MINUTES
DEVELOPMENT ADVISORY UNIT MEETING

3:30 PM Tuesday, 27 October 2026

UP26/129 Four Grouped Dwellings at No.6 (Lot 122) Redcourt Road, Attadale

Applicant:	Darklight Design
Owner:	By Vdk Developments No 1 Pty Ltd
Proposal:	4 x Two Storey Grouped Dwellings
Attachments:	1. DEVELOPMENT PLANS 2. PERSPECTIVES

Figure 3: Section of Lot 1 development seeking design principles assessment to northern boundary (Marked in Green)

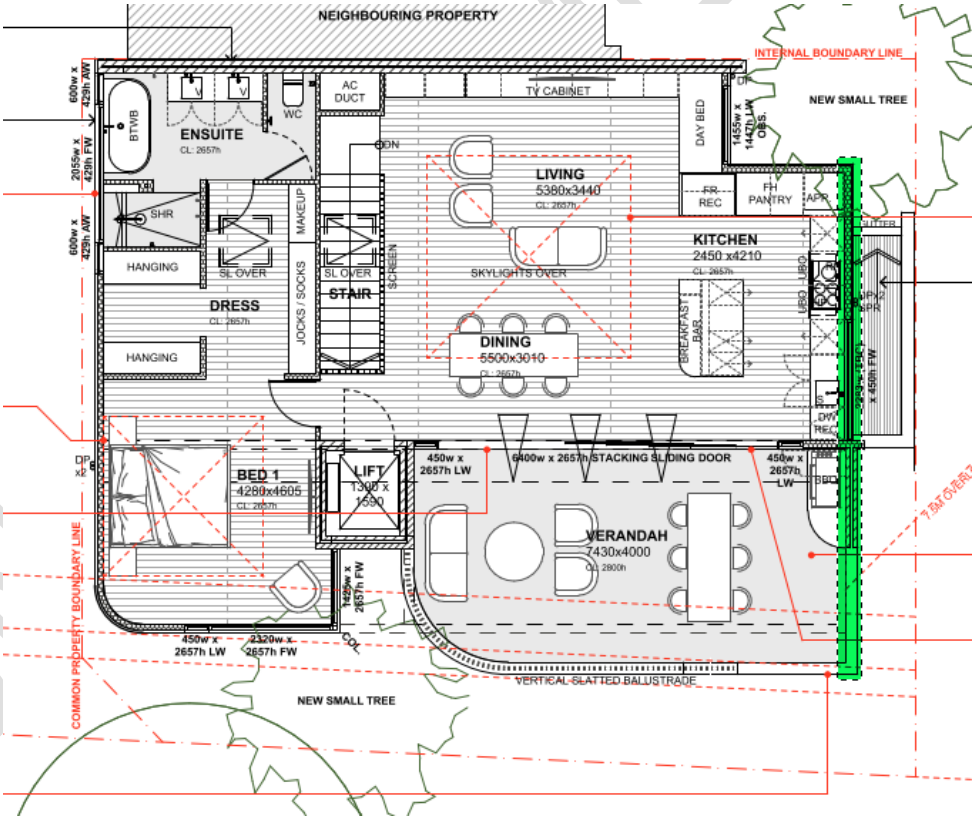
Concerns were raised by submitters in relation to the proposed northern side lot boundary setback from Lot 1 on the upper floor (balcony wall/kitchen), See Figure 1 below.. As noted above in the requirements section, the subject northern side lot boundary setback requires a design principles assessment. The proposed development is considered to meet the relevant design principles as discussed below:

The proposed setback provides an appropriate transition and separation between Lot 1 and the adjoining lots. In particular, the proposed setback is not indicative of the overall development pattern, with the other north-facing upper-floor walls associated with Lots 2, 3 and 4 being setback 1.5m or greater. This provides greater separation between the upper floors of the development and assists in avoiding a continuous built form in close proximity to the northern neighbouring lot boundary.

The setbacks provided to the northern side lot boundary provides separation between the buildings and will allow for sufficient sunlight and ventilation access into the open spaces within the development. This assists in maintaining opportunities for solar access and natural ventilation across the development. The orientation of the lot ensures that the neighbouring northern property will not have reduced access to sunlight from the proposed development.

Overall, the proposed setback is considered to provide an appropriate built form outcome. The increasing setback to Lot 1 and the greater setbacks provided to Lots 2, 3 and 4 prevent the upper floors from presenting as a continuous building mass along the northern boundaries and provide appropriate separation for solar access, ventilation and privacy. The proposal is therefore considered consistent with P3.4.1, P3.4.2 and P3.4.3 and is supported.
